## Subject: Western Star ECC Park Brake Output Signals

**Models Affected: Specific Western Star 4700, 4900 and 6900 models with Cummins EPA10 engines manufactured May 12, 2010, through January 29, 2013.**

Daimler Trucks North America LLC, on behalf of its wholly owned subsidiary, Western Star Trucks Sales, Inc., is initiating Field Service Campaign SF483A to modify the vehicles mentioned above.

June 2013  
SF483A

**Fig. 1, Brake Supply Air Line and Brake Air Pressure Switch**

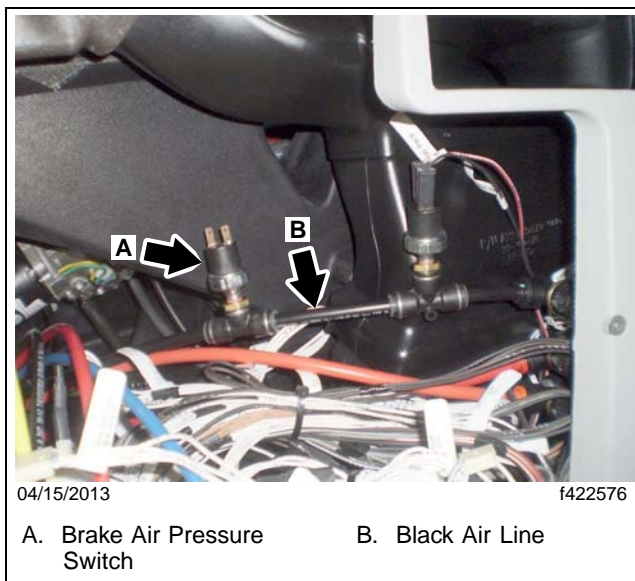
The park brake input signal will be moved from the ECC to an independent air switch.

7. Install the tee and air pressure switch (from the kit) into the park brake supply air line. See **Fig. 1**
  8. Using parts from the kit, attach the terminals and connectors to the ends of the new wires.

9. Connect the new wires to the new park brake air pressure switch.
  10. Route the new wires back along the existing wire loom to the ends of wires 440X and 440G and trim off any excess length.

**Fig. 2, ECC Connector**

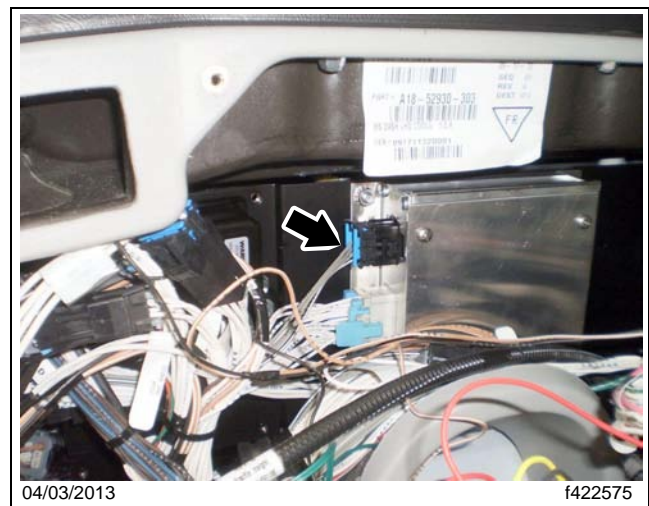
If wires 440X and 440G have not been relocated to a separate switch, and are still connected to the ECC as shown in **Fig. 2**, go to the next step.

11. Remove wires 440X and 440G from the ECC connector pins G and H. See **Fig. 2**.
  12. Remove and discard the existing terminals from the wire ends of 440X and 440G.

13. Using the crimp, solder, and seal Butt connectors (from the kit), connect the new wires from the new park brake air pressure switch to wires 440X and 440G.
